PRIVATE PLAN CHANGE 103
ADDENDUM HEARING REPORT
1636-1738 DAIRY FLAT HIGHWAY AND 193
WILKS ROAD, SILVERDALE, AUCKLAND 0792
FLETCHER DEVELOPMENT LIMITED AND
FULTON HOGAN LAND DEVELOPMENT

Reporting on proposed Private Plan Change 103 - 1636-1738 Dairy Flat Highway and 193 Wilks Road, Silverdale, Auckland 0792 Private Plan Change to rezone Future Urban Land at Silverdale West to Light Industry.

**Addendum
Hearing Report for Proposed Private Plan Change 103: Silverdale
West Industrial Area to the Auckland Unitary Plan (Operative in
part)
Section 42A Hearing Report under the Resource Management Act
1991**

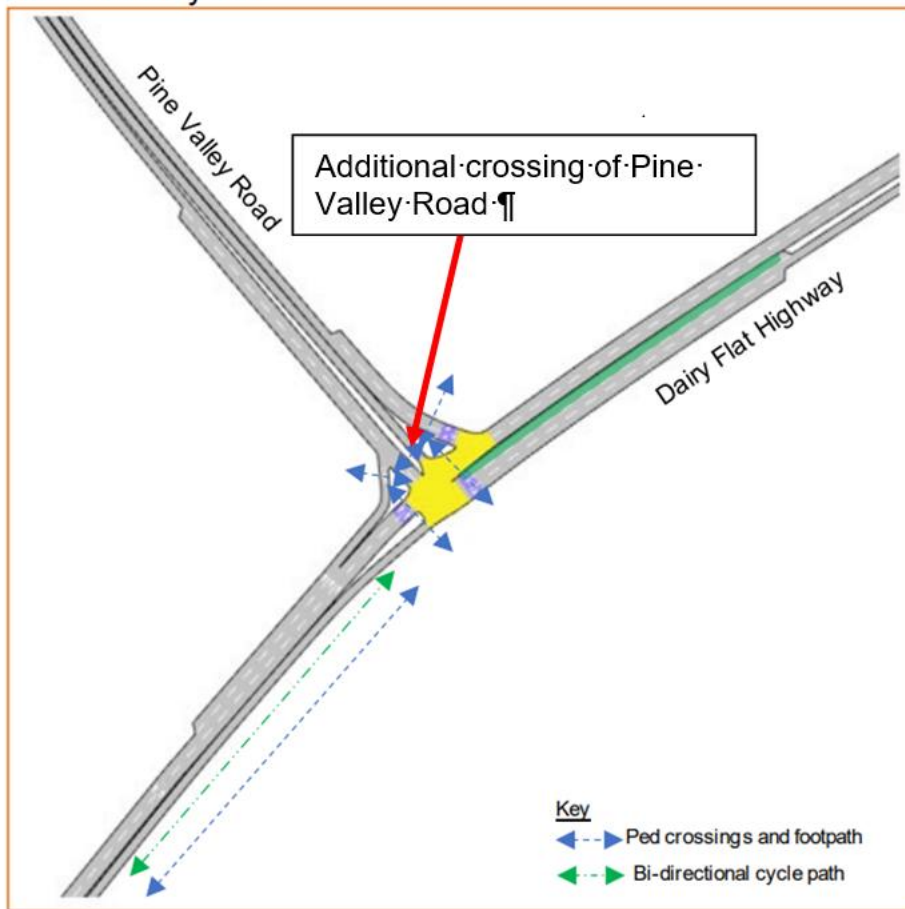
36. In relation to AT's submission points 14.47 and 14.48 which seek changes to the PC103 notified Precinct Appendix 1 and Appendix 2 relating to road function and design, the Requestor has proposed amendments to PC103 as notified, including amended Road Design Tables IX.11.1 Appendix 1 and IX.11.2 Appendix 2. However, these are different to the Road Design Tables submitted by AT. Mr Richards also addresses the proposed amendments in his Addendum Technical Memorandum (AR 2 (1) Section 4. He outlines that the suggestions in the AT submission have not been addressed including:

Widening the minimum road reserve for collector roads and local road by 3m (however it is noted that these cross sections don't have any on-street parking).

He notes that there are also issues with the provision of on street parking and the width of the roads and that these do not align with the cross sections shown in the ITA. The Requestor needs to address the revised tables in its evidence. AT also needs to comment on the Requestor's amended tables in its evidence.

IX.10.1 Precinct Plan 1-Silverdale West Industrial Precinct: ~~Precinct plan 1~~

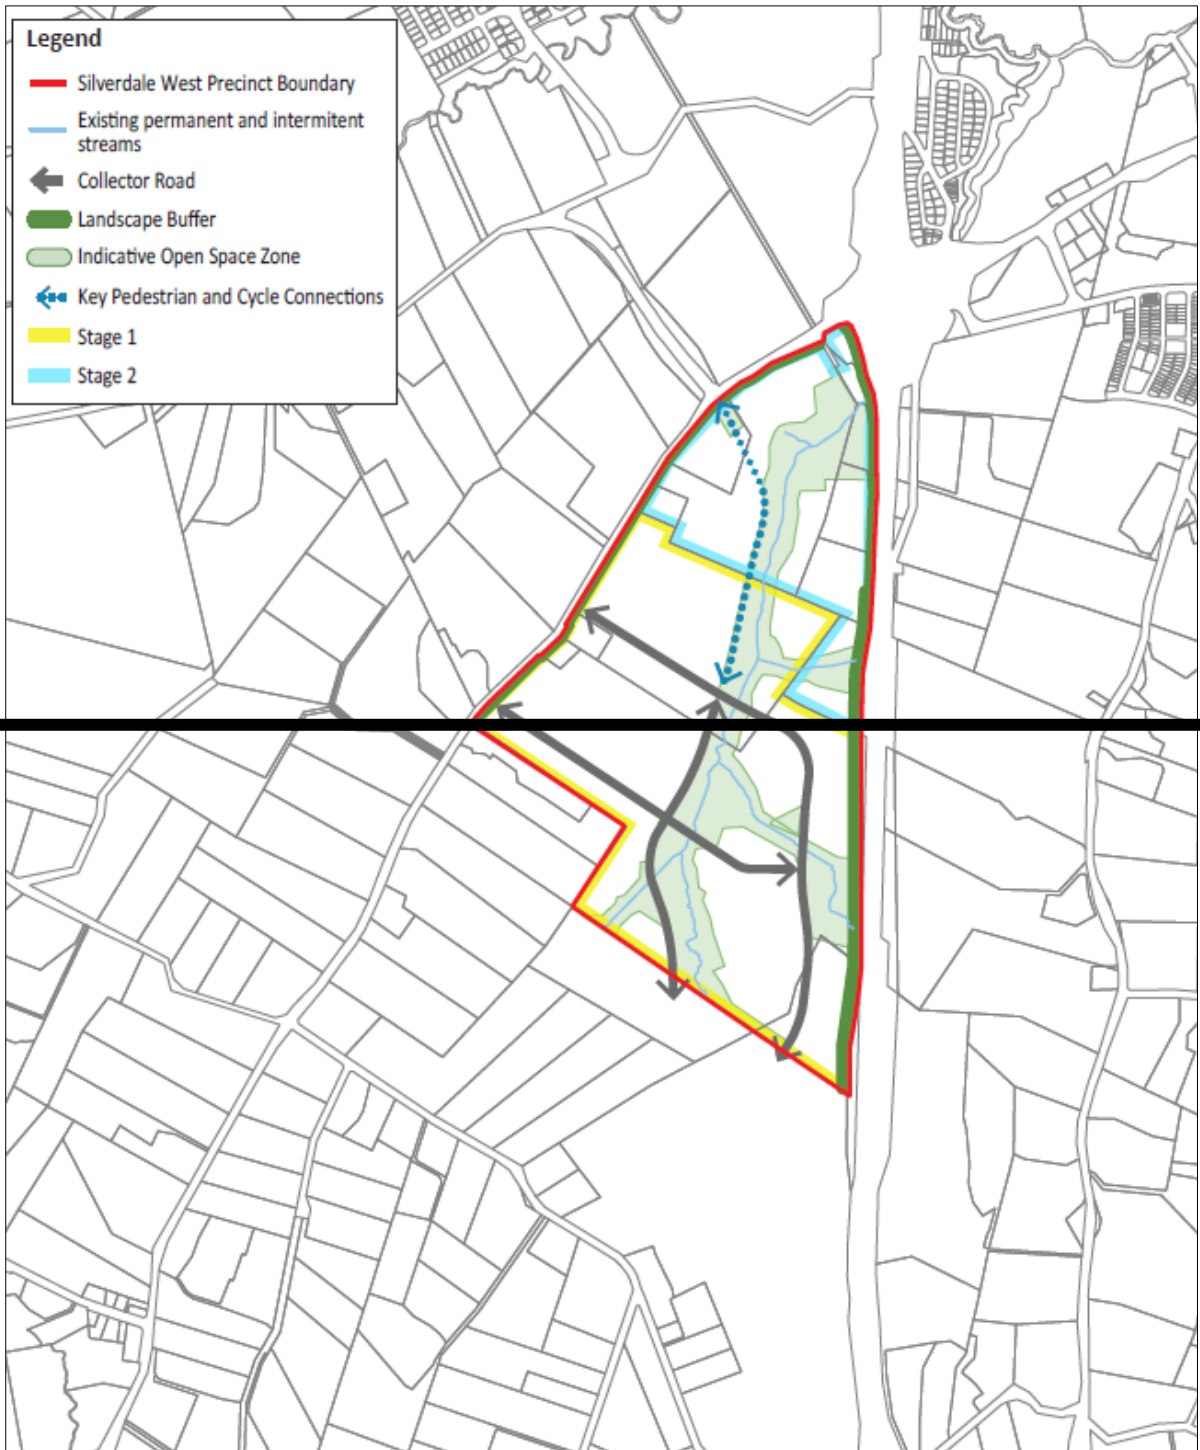
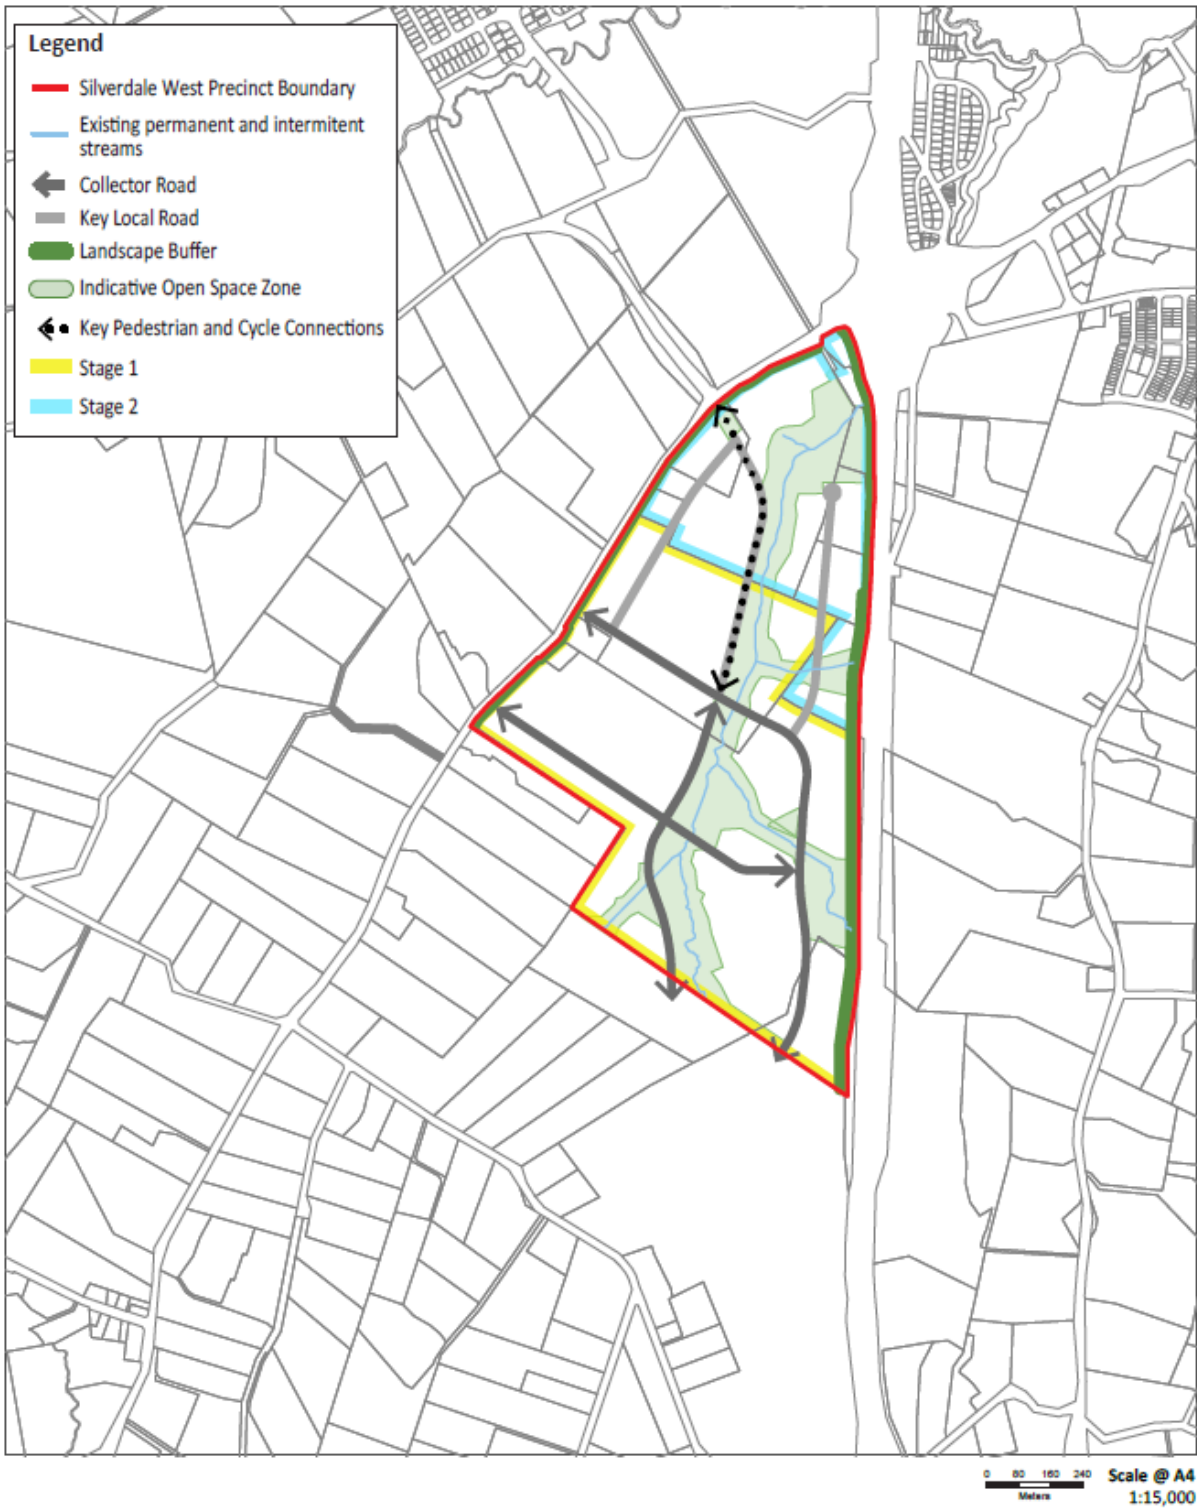
34. In relation to submission points 14.46 by AT and 15.2 by YJS Holdings, the Requestor has sought to address these points by identifying collector roads in Precinct Plan 1 and proposing a new standard in IX6.9 Road Design relating to ensuring that internal roads extend to adjoining property boundaries. Mr Richards also recommended this in his technical memo (Attachment 2 Appendix 2(6) of my Primary 42A Report). In my Primary s42A Report I recommended that the submission points be accepted, and a collector road be shown on the Precinct Plan. Mr Richards has addressed the proposed amendments in his Addendum Technical Memorandum (AR 2(2)). Mr Richards notes that proposed amendment does not represent all of the local road network, and is different to that shown, in the Requestor's ITA. The Requestor should address this difference in their evidence. Mr Richards also notes that:

The key pedestrian and cycle connection is shown on Precinct Plan 1 as being provided on the same alignment as key local road 2, however Table IX.11.1 Appendix 1: Road Function and Design Elements does not include provision for cycles on local roads (see Figure 3-2). If this section of road is to include cycle facilities, it may be more appropriate for this to be a collector road. Alternatively, it would be necessary to describe how this section of cycleway will be accommodated within the local road cross section.

The Requestor and AT should address this in their evidence. Mr Richards accepts that the Requestors proposed amendment to the PC103 notified Precinct Plan does

provide access to the Stage 2 area which is what is requested in the submission. As outlined above, the proposed amendments to PC103 as notified by the Requestor do not represent all of the local road network and is different to that shown in the Requestor's ITA. The Requestor should address this difference in their evidence.

35. However, AT needs to address whether the key intersections that require a transport design report and strategic cycle connections should be shown on Precinct Plan 1. The submitters need to address the proposed standard in their evidence. Subject to their evidence, I recommend accepting submission points 14.46 and 15.2 by identifying collector roads in Precinct Plan 1 and including new standard in IX6.9 Road Design as proposed by the Requestor.

Upgrade 2 (Table IX.6.7.1 (b) of the Precinct Provisions)

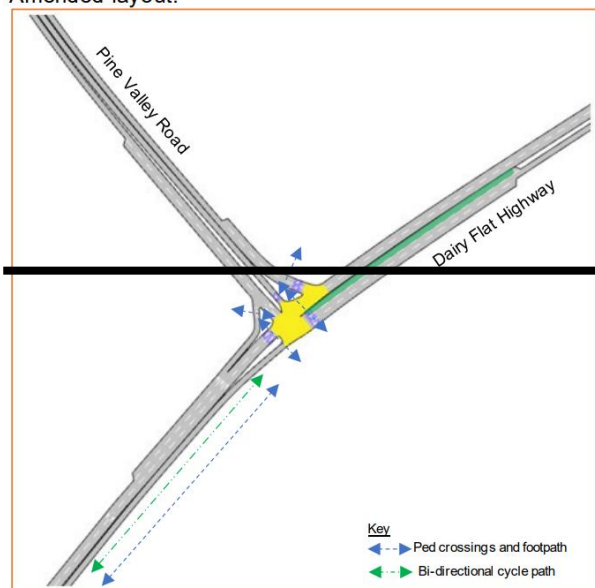
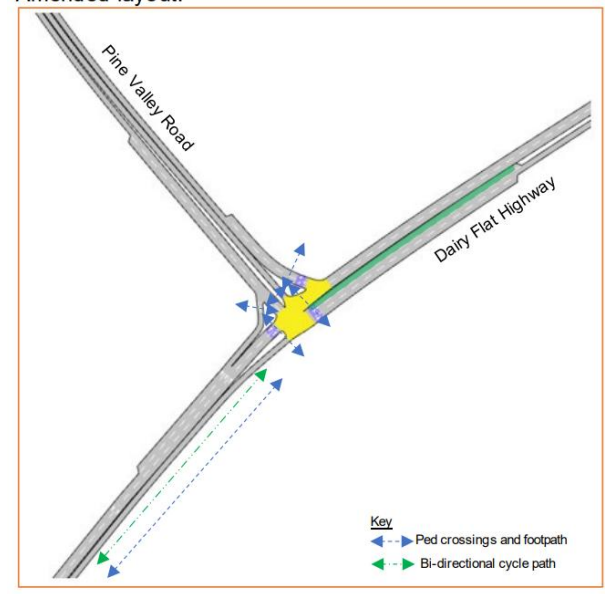
37. In its proposed amendments to PC103 as notified, the Requestor seeks to address AT's submission point 14.48 under the heading IX11.3 Appendix 3 Transport Infrastructure Upgrades. I believe this is an error and it should refer to AT's submission point 14.49 which relates to IX.11.3 Appendix 3: Transport Infrastructure Upgrades (see table above). Submission point 14.48 relates to Appendix 2 Road function and design and was discussed above. The Requestor needs to clarify this in its evidence.
38. I note that the Requestor indicated that there are amendments to the notified PC103 Appendix 3 Upgrade 2. However, it is not clear from the Requestors amended material what the change is, but I have shown it in the enlarged diagram below. The change shown addresses AT's submission 14.9 about a pedestrian crossing being added across Pine Valley Road.

39. The Requestor needs to clarify that this is the only change proposed to Appendix 3. Mr Richards notes that the proposed amendment does not address the comment in AT's submission about the intersection being remodelled. The Requestor and AT should address these points in their evidence.

(Note: The Amended Layout plan below right includes a proposed amendment to add a pedestrian crossing on Pine Valley Road)

Figure 3-1 Precinct Plan 1 (previous) and Proposed

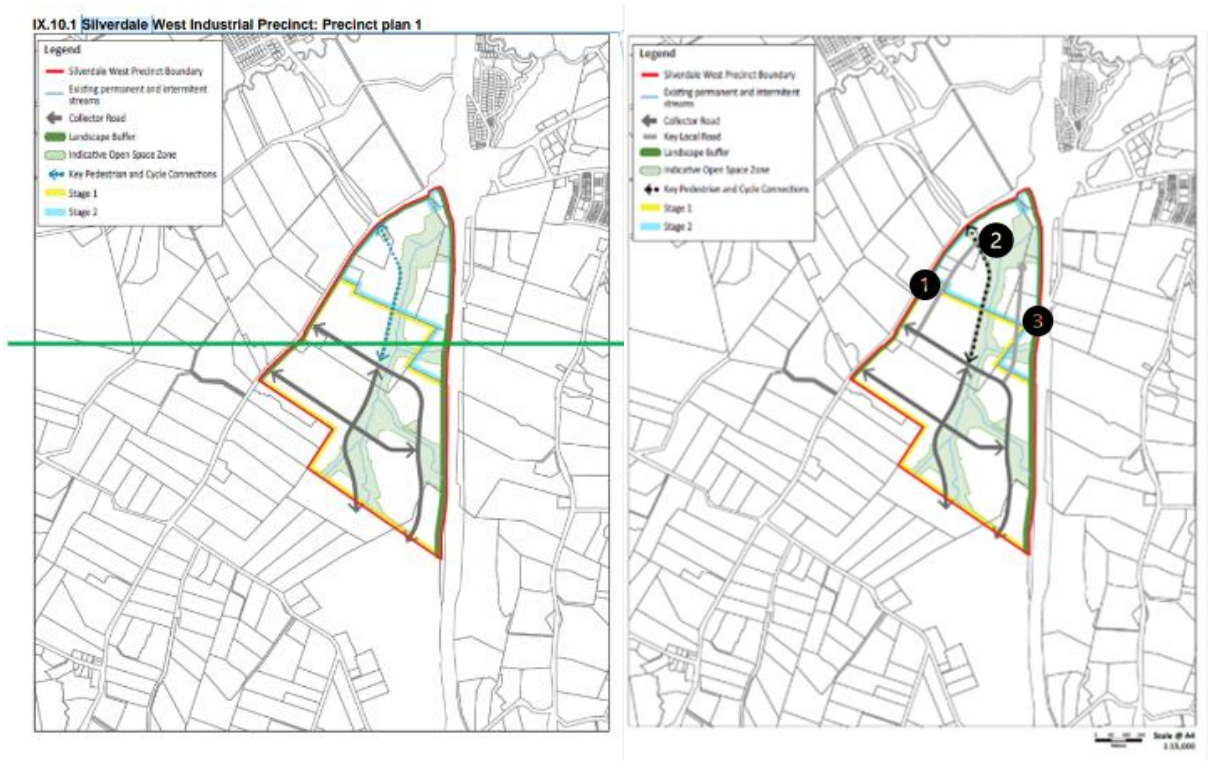
IX.10.1: Silverdale West Industrial Precinct: Precinct Plan 1 has been updated to include key local roads in the internal roading network. I have numbered these key local roads 1, 2 and 3 in Figure 3-1 below.

These key local roads do not represent the entire local road network and present a different network to that shown in Figure 3 of the ITA. However, Precinct Plan 1 does now include an internal road network to and within Stage 2 of the Plan Change, which responds to a request raised in submissions.

The key pedestrian and cycle connection is shown on Precinct Plan 1 as being provided on the same alignment as key local road 2, however *Table IX.11.1 Appendix 1: Road Function and Design Elements* does not include provision for cycles on local roads (see Figure 3-2). If this section of road is to include cycle facilities, it may be more appropriate for this to be a collector road. Alternatively, it would be necessary to describe how this section of cycleway will be accommodated within the local road cross section.

Figure 15: Indicative Cross Section – Collector Road

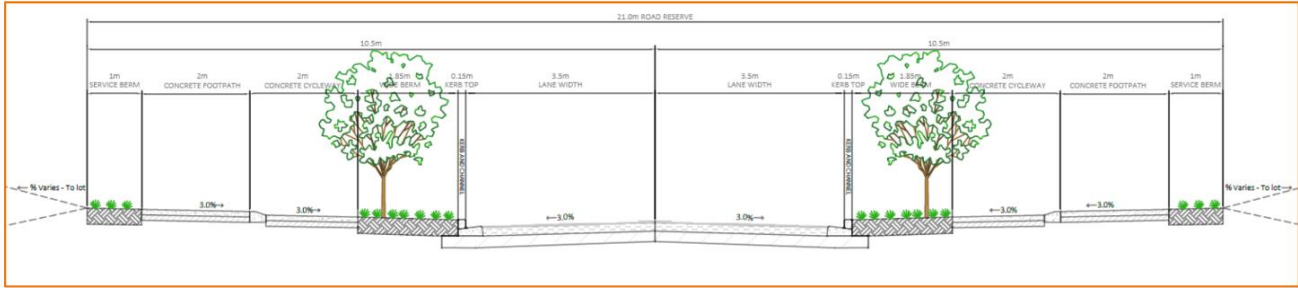
There are also new provisions for the collector and local road cross sections to not have on-street parking. This is contrary as it states a cross section width (without on-street parking) and the adjacent column states on-street parking is optional. This doesn't align with the 21m cross section in ITA and would not fit in the 1.85m berm with on-street parking, so the corridor width may need to be wider.

There is a new provision for a collector road to accommodate a 3m wide flush median. It is unclear how this would be accommodated within the 21m wide cross section, and this is also different to that shown in Figure 15 of the ITA. Again we expect the road reserve will need to be wider than shown.
